20231197 – BL453 – Harper Hall – Replace Electrical Service
Addendum 1

November 21, 2025

SHEET TITLE
**SITE PLAN
ELECTRICAL**

PROJECT NO.	SHEET NUMBER
14.06060.00	E1.03
DATE Jan. 27, 2015

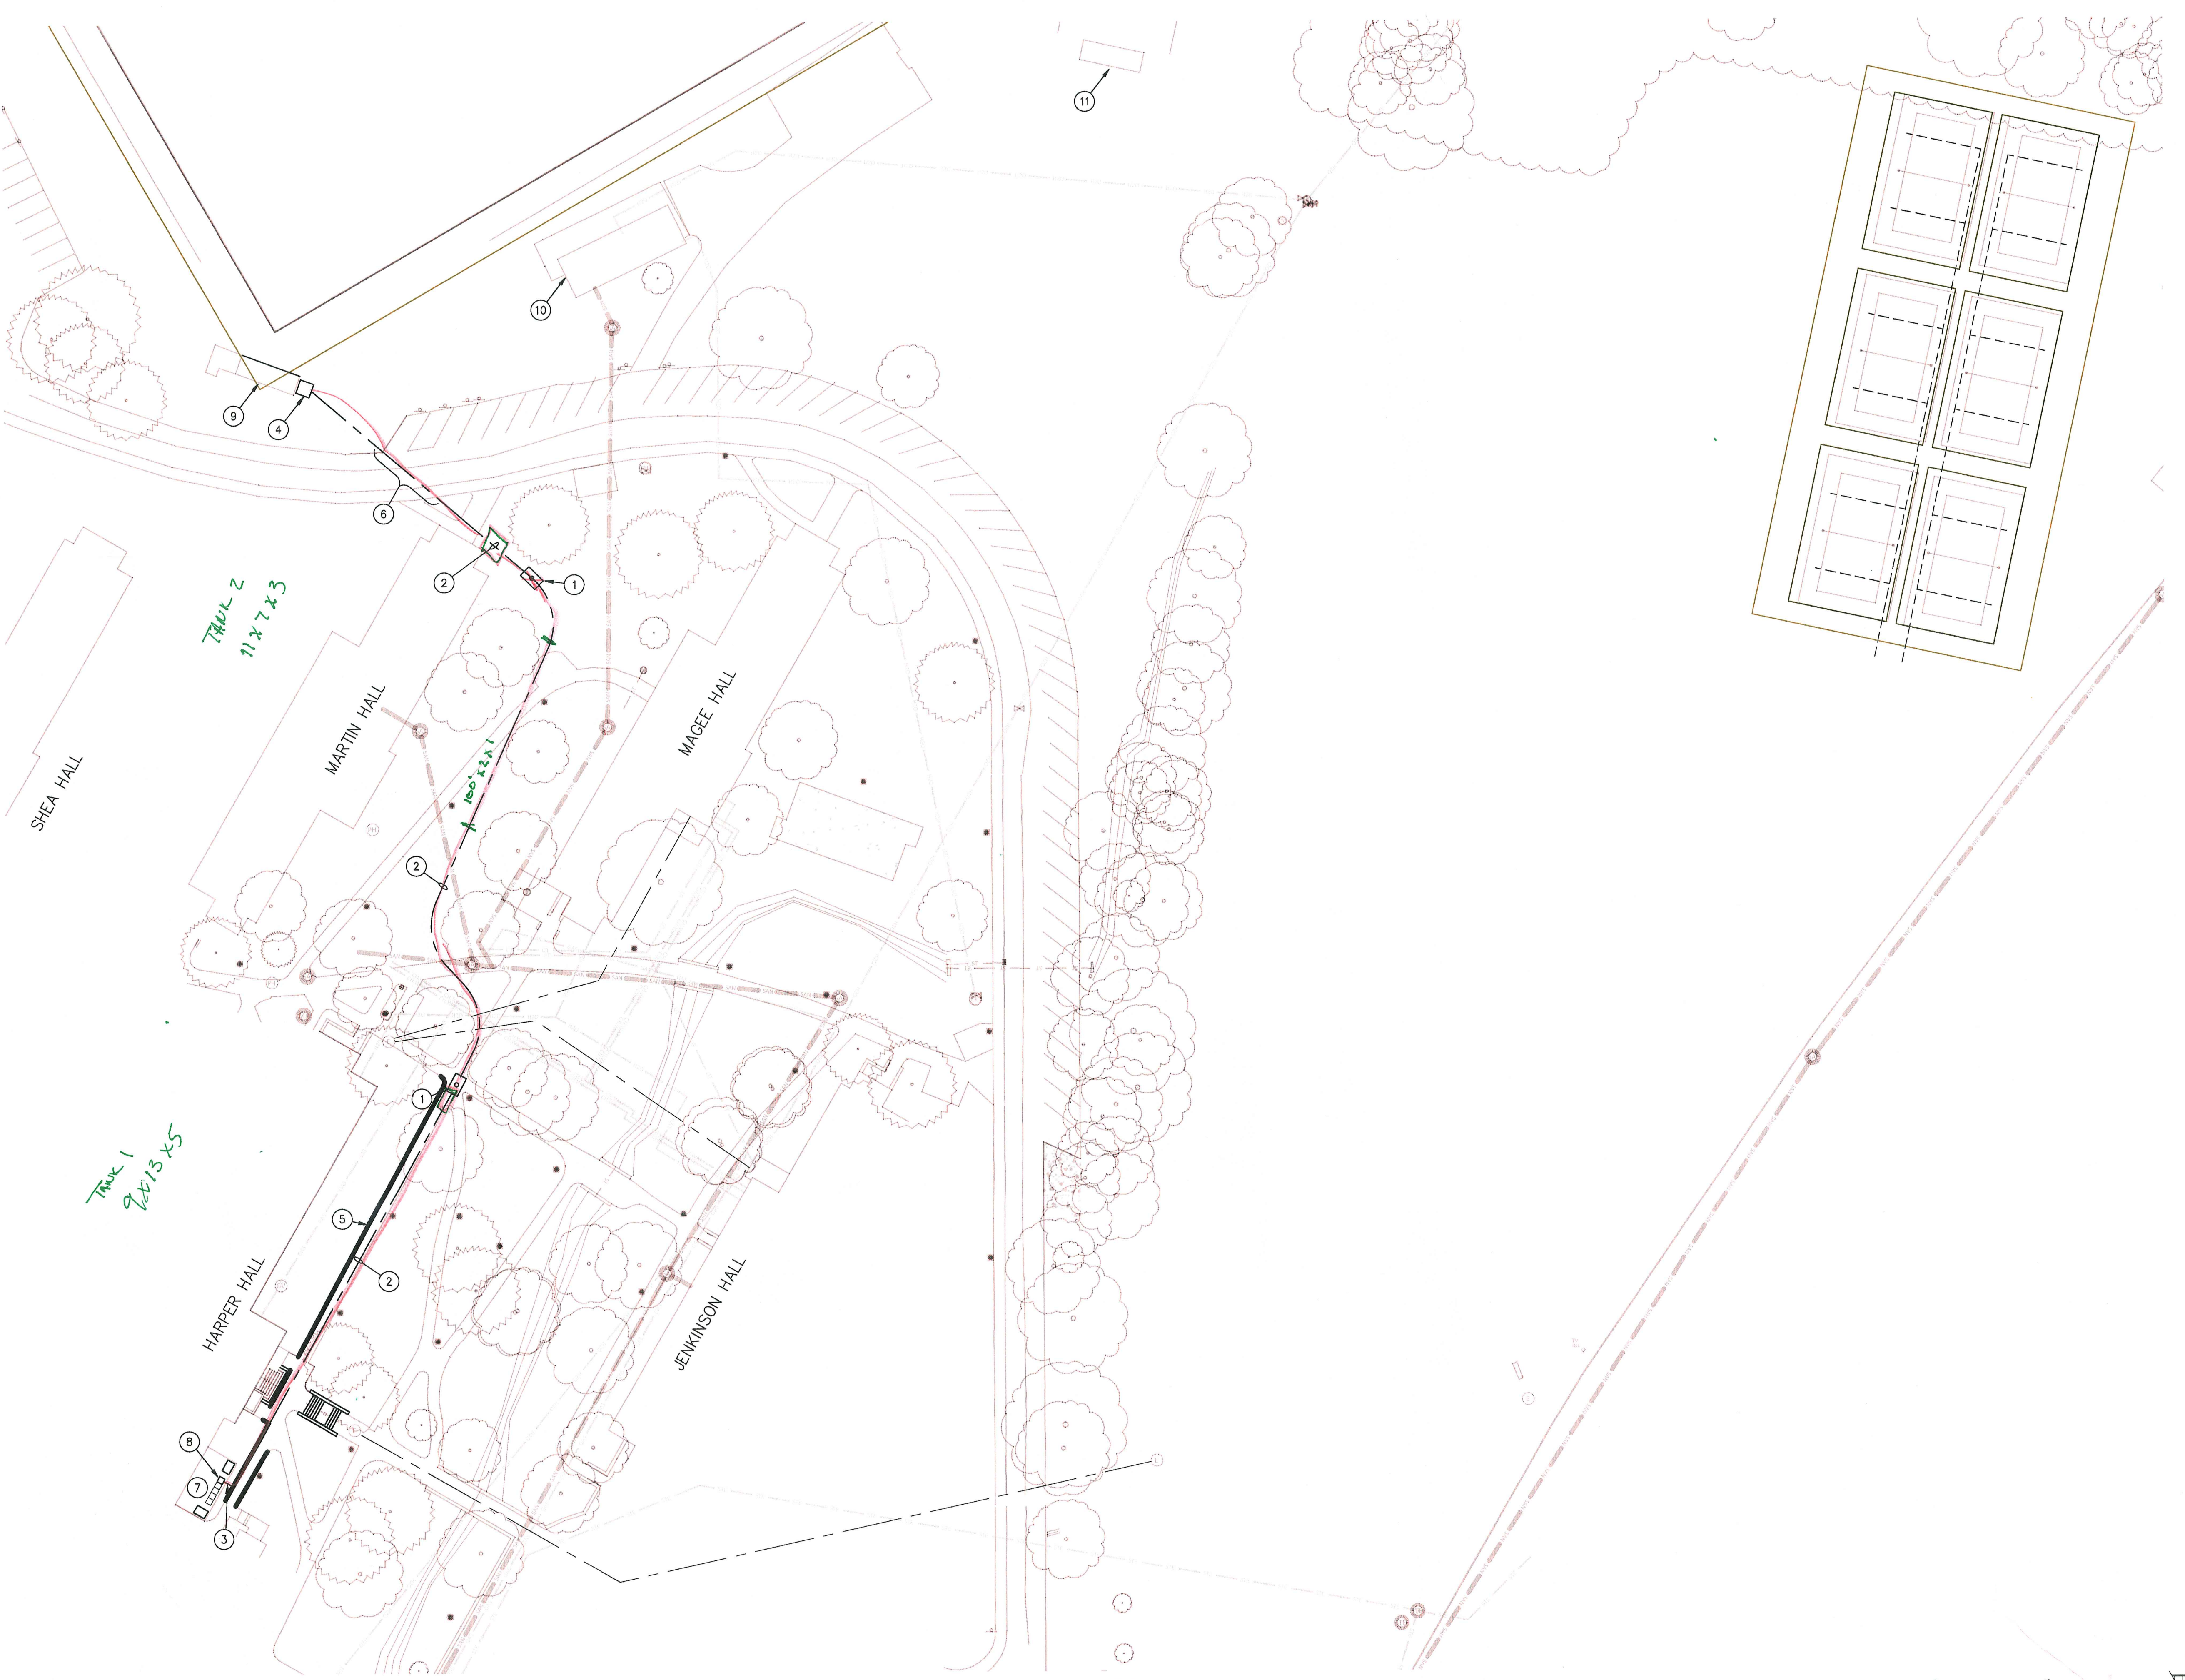
Question 3: Where is the vault for the Sports Rec feed?

Question 6: For the alternate bid, I need to know where the manhole is located and if there are T mods and racking.

Answer 3: Based on as-built records, provided by Indiana University, there is a manhole just northeast edge of Harper Hall. See attached as-built sheet E1.03

Answer 6: Based on Sports Rec as-builts, the first manhole from Harper should be located at the northeast edge of the building. It is not known if the cable has T-mods or racking in that manhole.
